Re: FCC Class II Permissive change for FCC ID: 2AB9V-J12  
Date: 2015 May 28

This is to request a Class II permissive change for FCC ID: 2AB9V-J12, originally granted on 2014 Nov 10.

Change #2: Trace change on the Battery routing

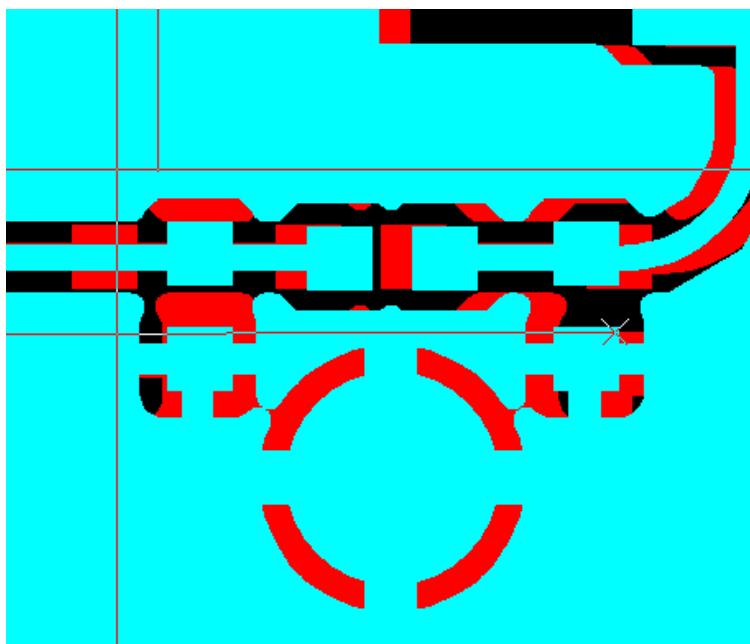
Red is the new version, Blue is the old version.

## Change 4#:

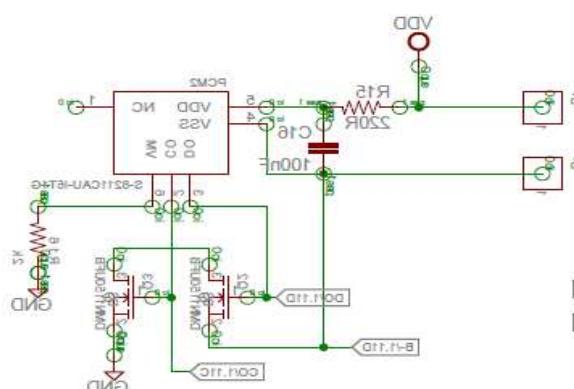
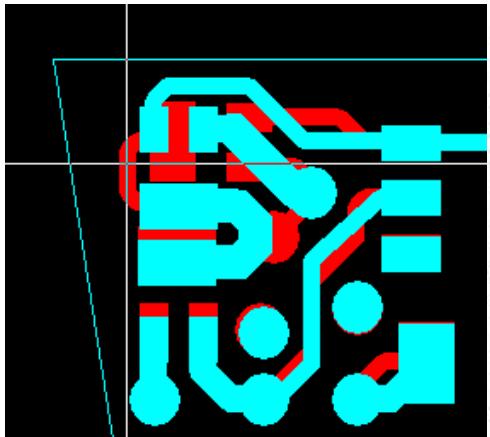
Q2 position change, rotate 90degree. Schematic unchange
